Docket Number:	15-AAER-02
Project Title:	Pool Pumps and Spa Labeling
TN #:	220517
Document Title:	Presentation - Efficiency Standards for Pool Pumps and Motors
Description:	By Jeff Farlow and Chris Wellborn of Pentair, August 3, 2017
Filer:	Sean Steffensen
Organization:	Pentair
Submitter Role:	Public
Submission Date:	8/2/2017 1:13:28 PM
Docketed Date:	8/2/2017

Efficiency Standards for Pool Pumps and Motors

Docket Number 15-AAER-02

U. S. DOE Alignment & Implementation Dates

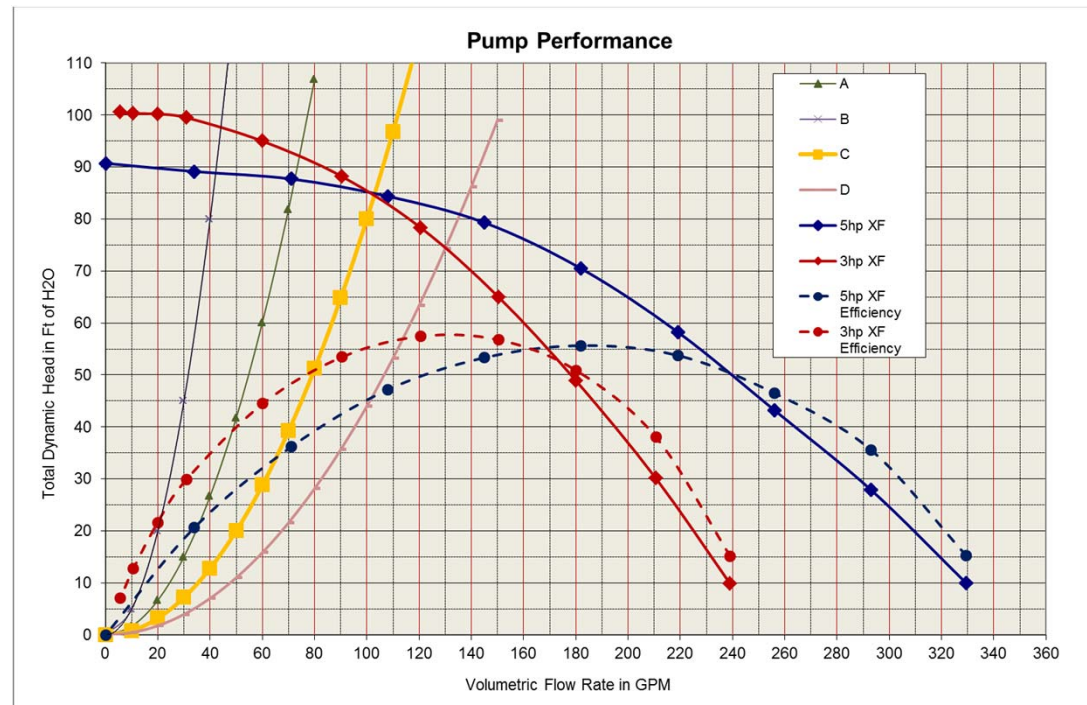
Pentair supports the U. S. DOE efforts to minimize pool pump energy consumption. Pentair was also very vocal on the need to close the replacement motor loophole. DOE has responded with a commitment to resolve that loophole and the initial meeting is scheduled next week, August 10, in Washington DC. The intent is to have the motor loophole issue resolved prior to the July 19, 2021 implementation date for DPPP.

Pentair is concerned that due to the lack of inspector presence at a retrofit/replacement motor installation, a CA-only regulation would be unenforceable due to the inability to prevent sales across state lines from other markets and/or the Internet. As such, we would urge CEC to work through the DOE process to adopt Federal legislation that would be more enforceable.

Let the DOE process proceed without conflict
